FLOOD CONTROL PERMIT

The Water Management Board hereby approves Flood Control Permit No. FC-1 for M.C. Johnson, 607 W Bridge, Philip, South Dakota, 57567, to construct and maintain flood control facilities located in the east forty feet of the east 140 feet of Lot B; west 100 feet of the east 140 feet out of Lot B; both in Mann's Addition of the Town of Philip, T1N, R20E.

REPORT ON M.C. JOHNSON
CHANNEL CHANGE

M. C. JOHNSON FLOOD CONTROL STRUCTURE

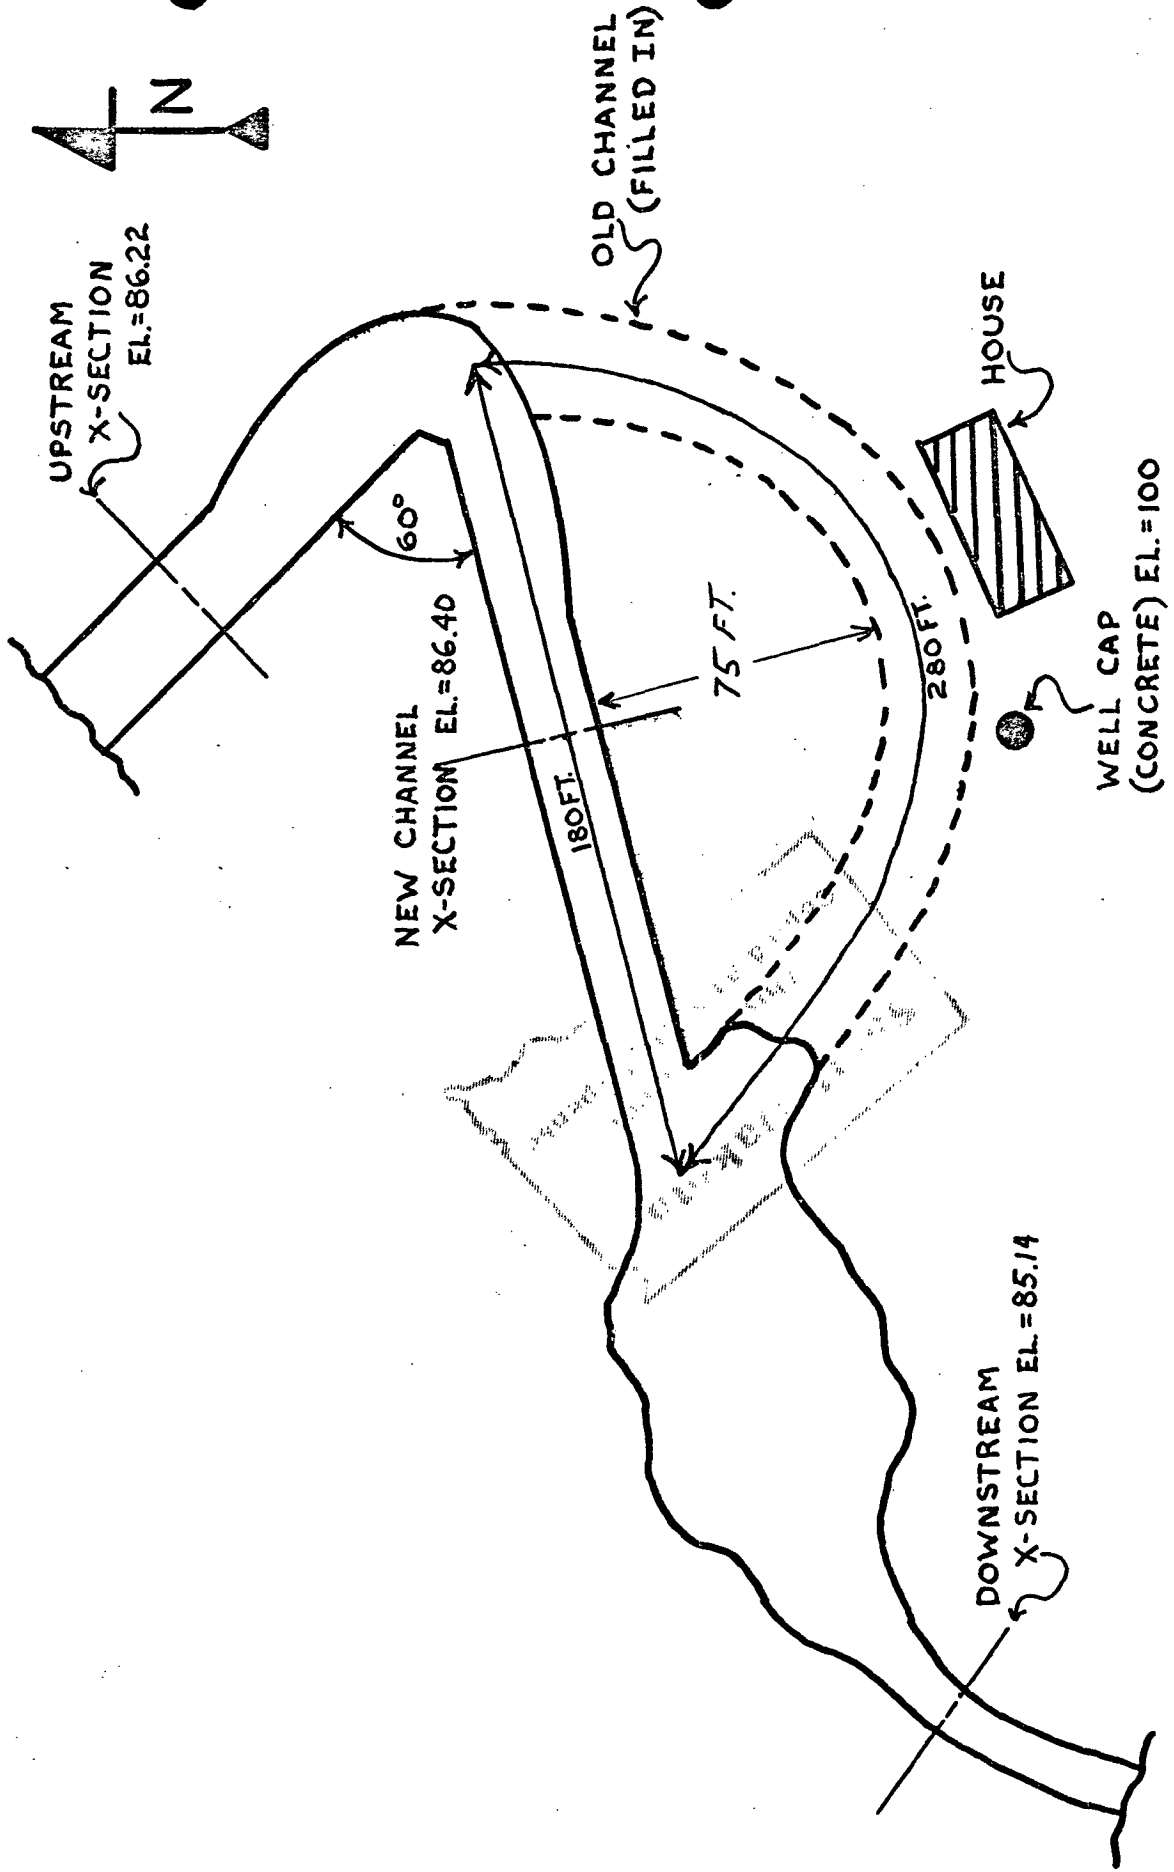
The depth of flow in the new channel caused by the 310 cfs is greater than the depth which would cause a supercritical condition, the flow would therefore be subcritical throughout this reach of the river. Because of the larger capacity of the new channel, flows normally occurring can easily be conveyed. The channel change will not cause any abnormal conditions of flow nor any critical conditions of flow.

The upstream channel capacity is one half of a two year flow. On the average flooding can be expected to occur every other year. Out of bank flow conditions would occur upstream before reaching the new channel. The new channel will not add to nor cause any change in the normal pattern of flooding. The channel alteration was made to protect the house from being undercut.

The 60° bend of the river channel from the upstream into the new channel as well as an increasing velocity will more than likely cause eroding of the embankment and will again cause the channel to move toward the house. Some bank statilization work should be conducted for the protection of this embankment.

Approximate upstream end of channel:

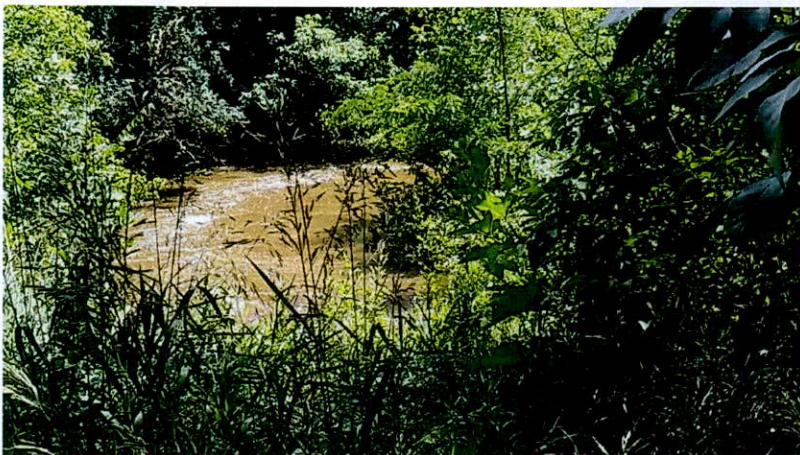
C. Condition and Location: The Bad River in the immediate vicinity of the channel reconstruction appears relatively stable. The old oxbow which was filled is vegetated and floods when the River is at high stage and out of its banks. There is a considerable amount of woody debris partially obstructing flow just upstream of the sharp bend at the beginning of the reconstructed portion of the river channel. The project seems functioning as intended.
